PLANNING ADMINISTRATOR DECISION FOR SITE PLAN REVIEW

CASE TYPE: Class 2 Site Plan Review
AMANDA NO.: 20-110194-RP
DATE OF DECISION: November 24, 2020
PROPERTY LOCATION: 4629 Sunnyside Road SE
APPLICANT: City of Salem – Public Works Department
(Ben Haney)
ZONE: PA (Public Amusement) and RS (Single Family Residential)
COMPREHENSIVE PLAN: Single Family Residential
OVERLAY: None

**IMPROVEMENTS TO THE AQUIFER
STORAGE AND RECOVERY
FACILITY**

SUBJECT: **PUBLIC WORKS RECOMMENDATIONS
CLASS 2 SITE PLAN REVIEW (20-110194-RP)
4629 SUNNYSIDE ROAD SE
SALEM ASR EXPANSION FACILITY**

**SCHEDULE A
TREATMENT FACILITY
SITE LAYOUT PLAN**

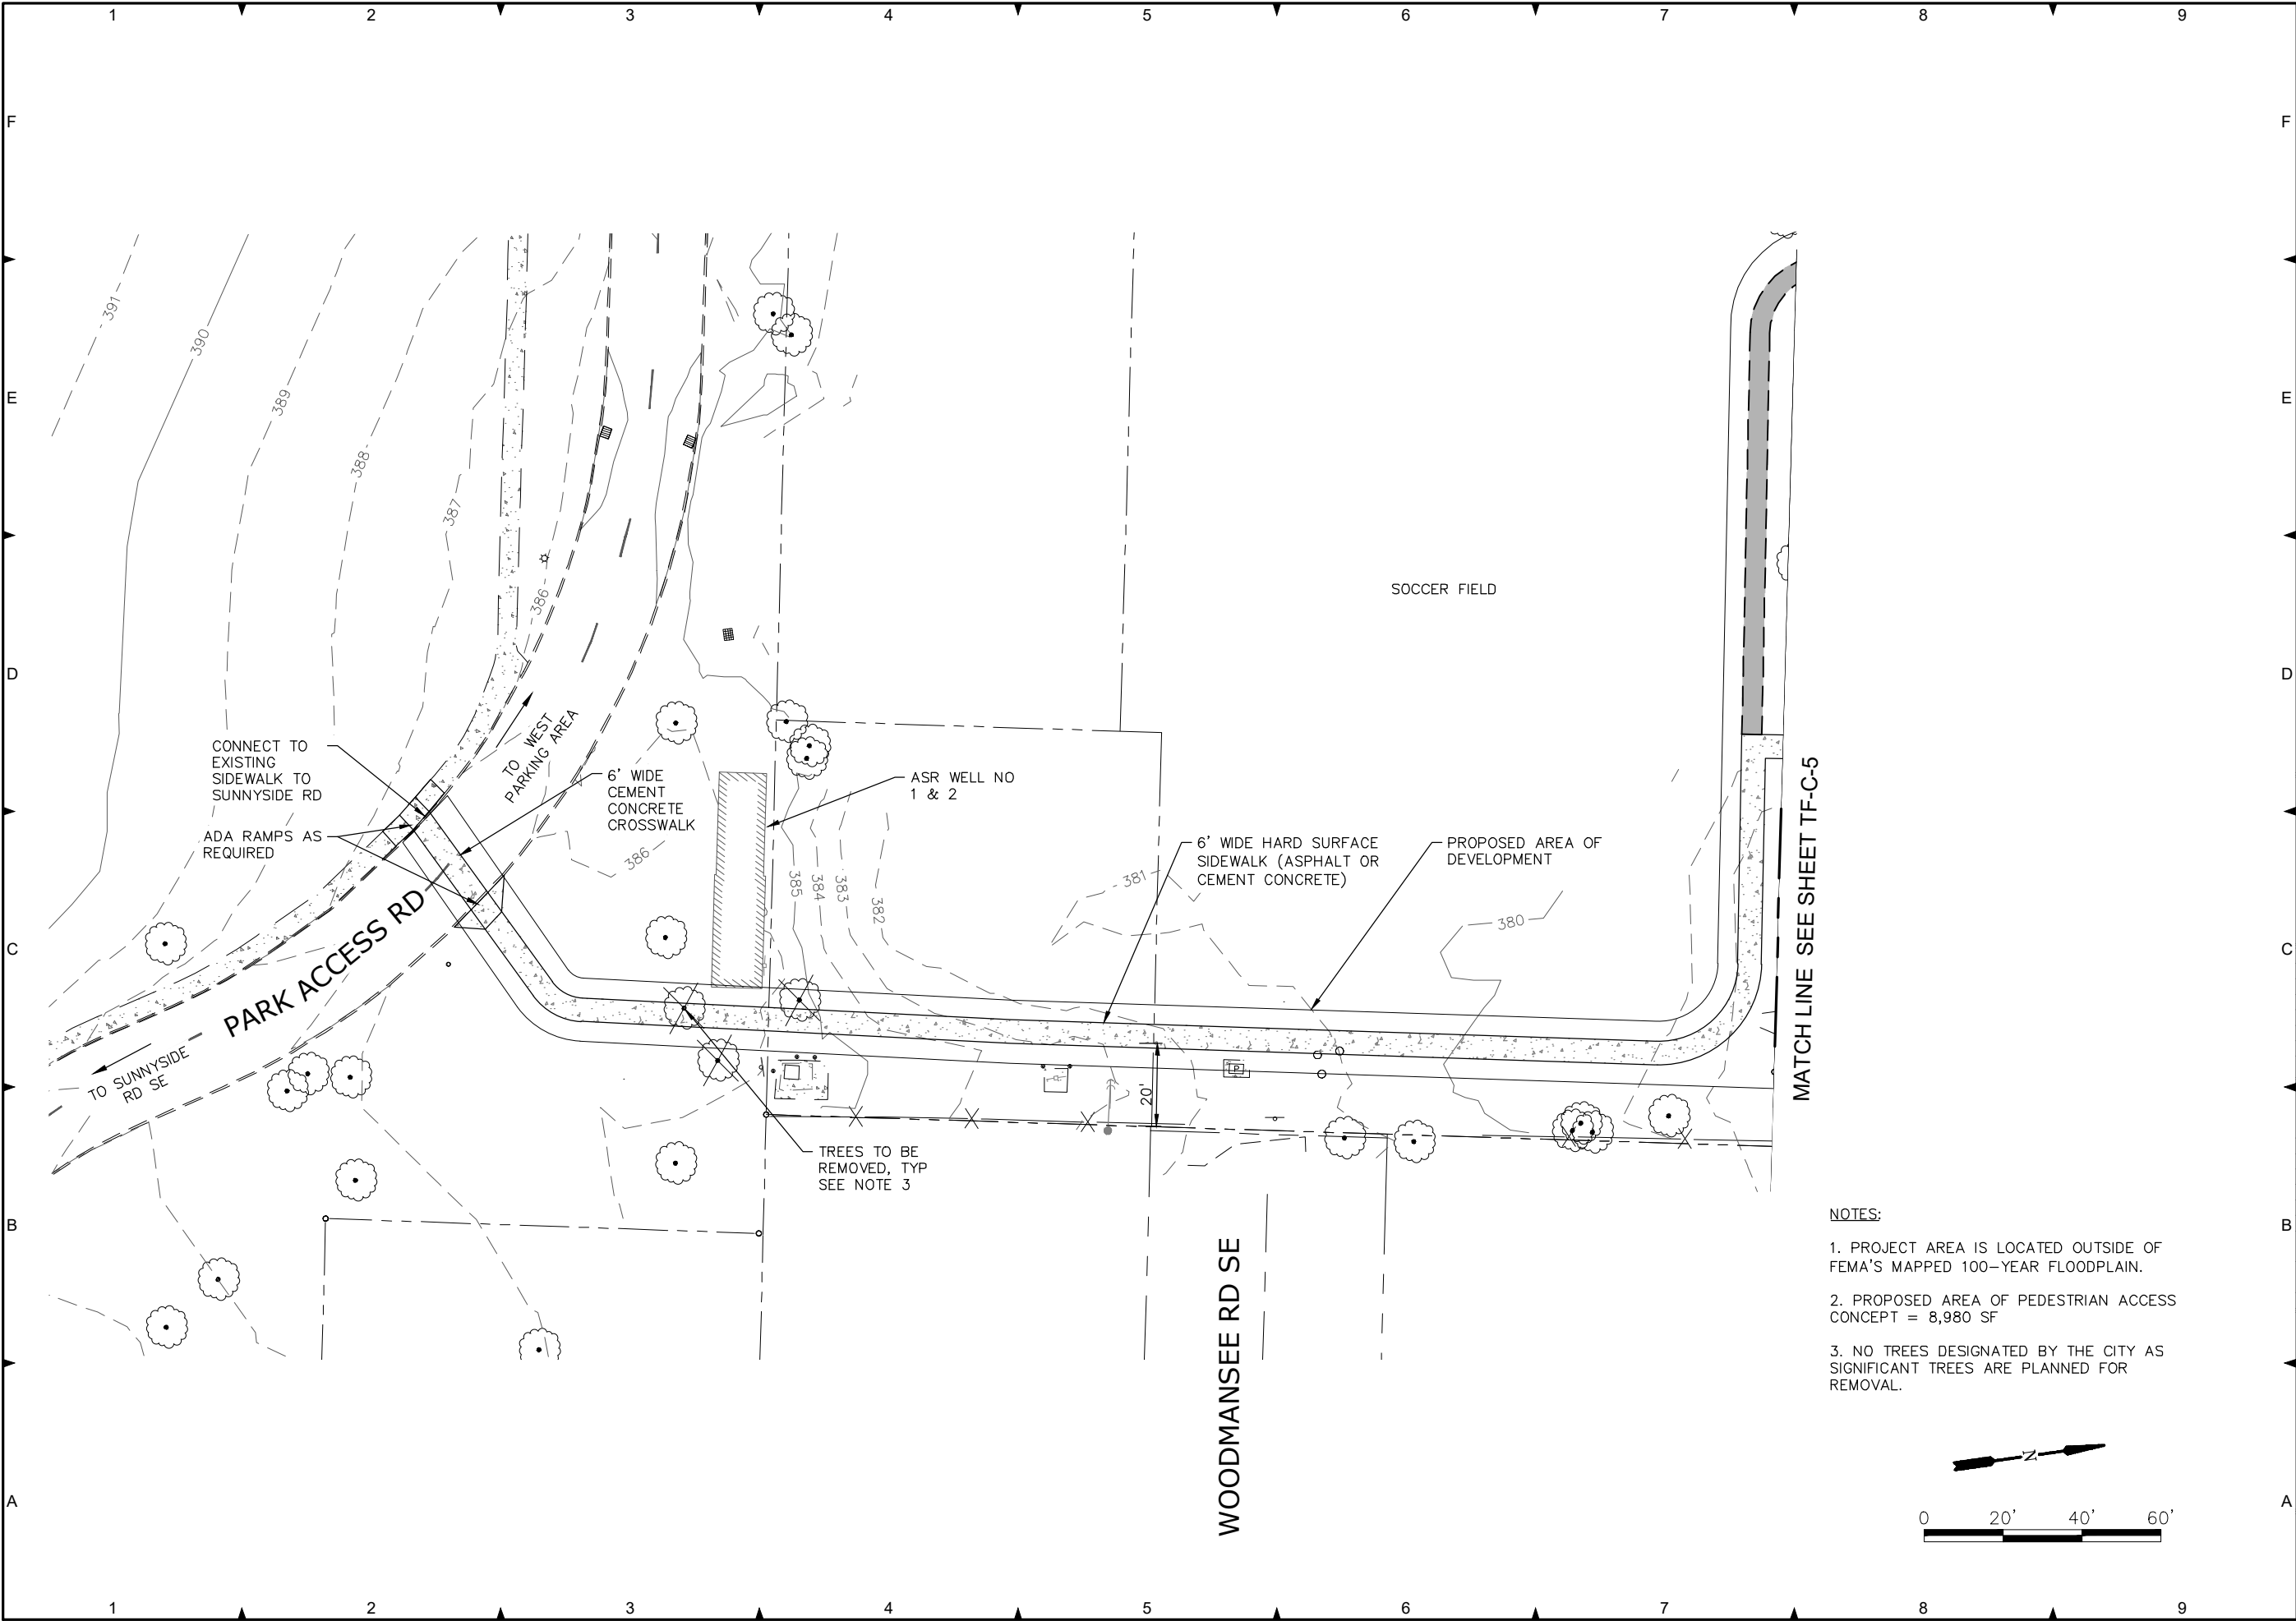
Finding: The proposed building is approximately 300 feet and the proposed vehicle use area is approximately 230 feet from the northern property line, meeting minimum setback requirements.

Finding: The proposed building is approximately 100 feet and the proposed vehicle use area is approximately 40 feet from the southern property line, meeting minimum setback requirements.

Finding: The proposed building is approximately 45 feet and the vehicle use area is approximately 25 feet from the eastern property line, meeting minimum setback requirements.

Finding: The proposed building is approximately 210 feet and the vehicle use area is approximately 170 feet from the western property line, meeting minimum setback requirements.

Finding: The proposed building is approximately 16 feet in height, and the 2,219 square foot building covers less than 0.2 percent of the lot area, meeting the standard.

Finding: The proposed building is approximately 2,219 square feet in size and the applicant indicates that there will be no employees, and based on the floor area of the building, no off-street parking spaces are required ($2,219 / 5,000 = 0.44$). The site plan indicates that three off-street parking spaces are provided. No compact spaces are proposed. Carpool/vanpool spaces are not required for the proposed use.

Finding: The site plan shows that four bicycle parking spaces will be installed on the north east side of the building entrance in compliance with the location and development standards of SRC 806.060.

Finding: The proposed off-street parking area is developed consistent with the additional development standards for grade, surfacing, and drainage. Bumper guards and wheel barriers are required in the proposed parking area so that no portion of a vehicle will overhang into a required pedestrian accessway. The parking area striping, marking, signage and lighting shall comply with the standards of SRC Chapter 806. Abutting property to the north is zoned RS (Single Family Residential); therefore, a minimum six-foot-tall sight obscuring fence, wall, or hedge is required to screen the proposed off-street parking area from the abutting residential use to the north.

Finding: Landscaping and irrigation plans are required at building permit to demonstrate that Type A landscaping of one plant unit per 20 square feet of landscaped area is provided between the parking and vehicle use areas and north,
